From: Brad Vowels-Katter, Zoning Administrator

Subject: General Development Plan (GDP) for Westfield Planned Unit Development (PUD) Mixed Residential and Commercial Development for Parcels 171-0516-2722, 171-0516-2811, and 171-0516-2814

Date: June 25, 2025

Figure 3: Westfield Development Phasing Diagram

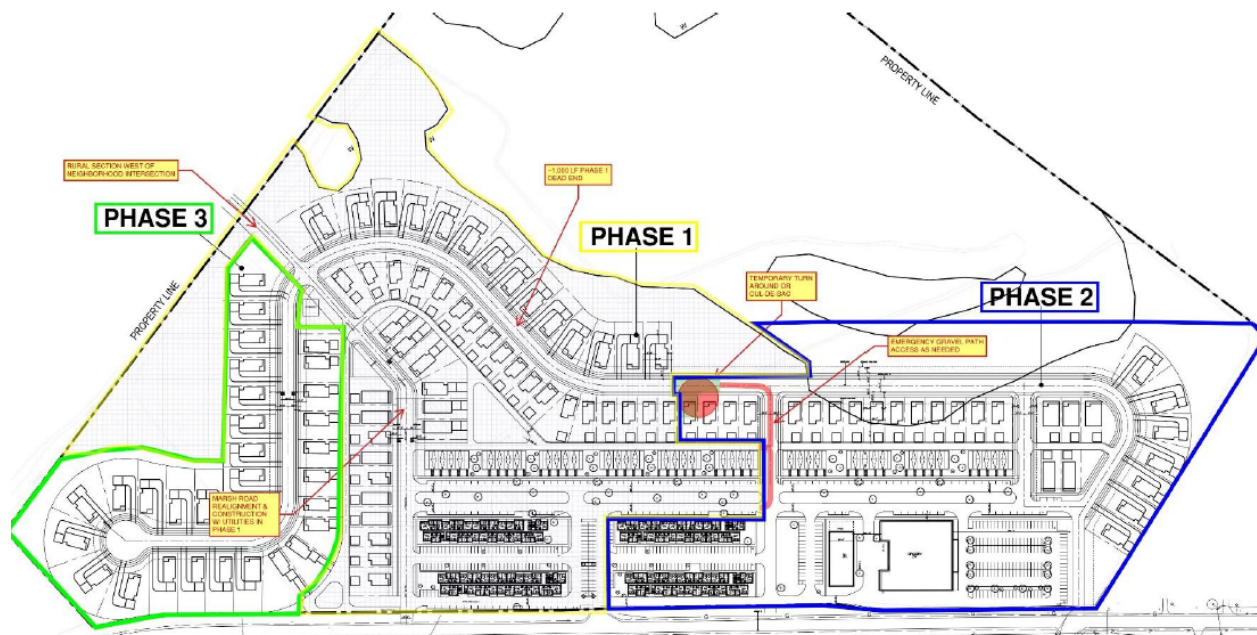
The applicant has outlined a phasing diagram of the site. A general phasing timeline should be proposed by the developer with general timeframes expected for construction.

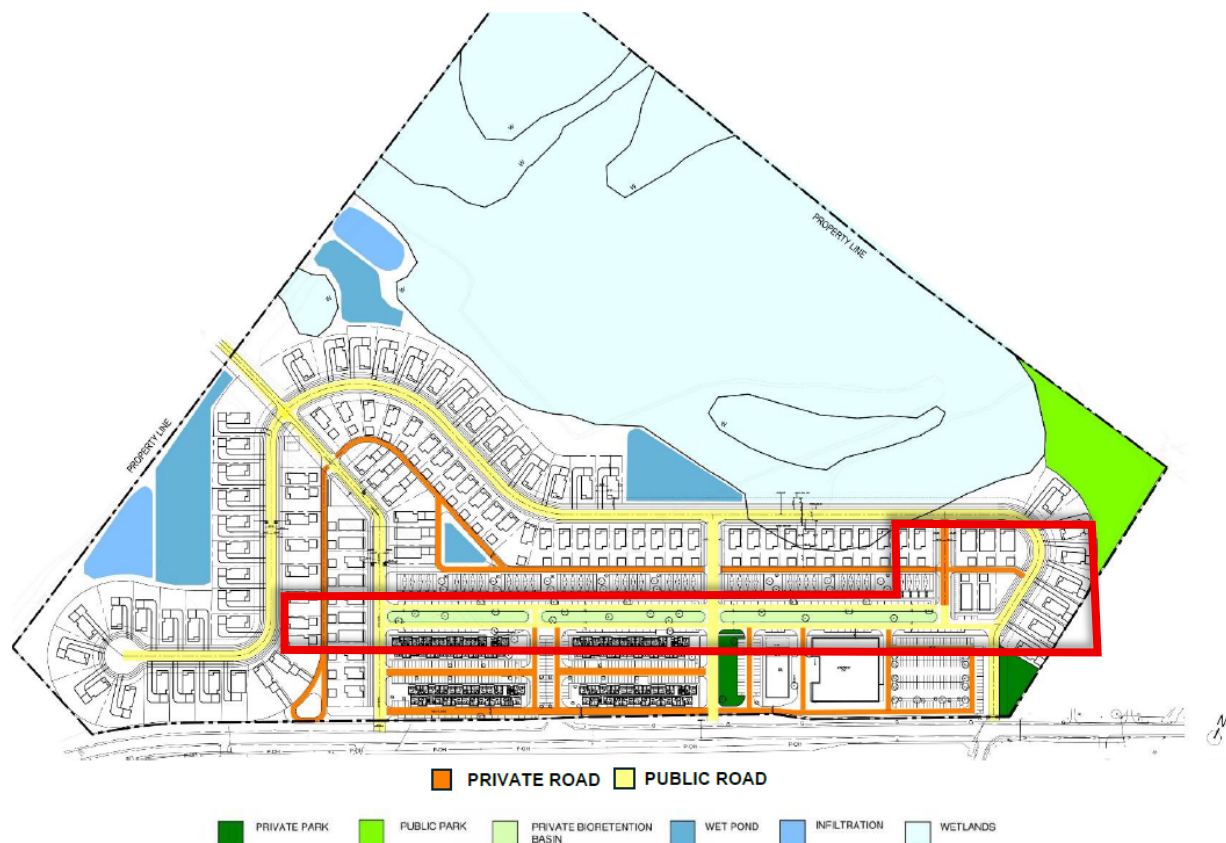
The applicant has requested waiver or exemption from the Off-Street Parking and Loading requirements pursuant to Section 17.12(4) as a flat rate of 1 space for every 200 square feet of commercial space. Parking requirements for commercial uses varies by establishment from 1 parking space for every 75 square feet plus employee parking to 1 parking space for every 250-300 square feet of usable space.
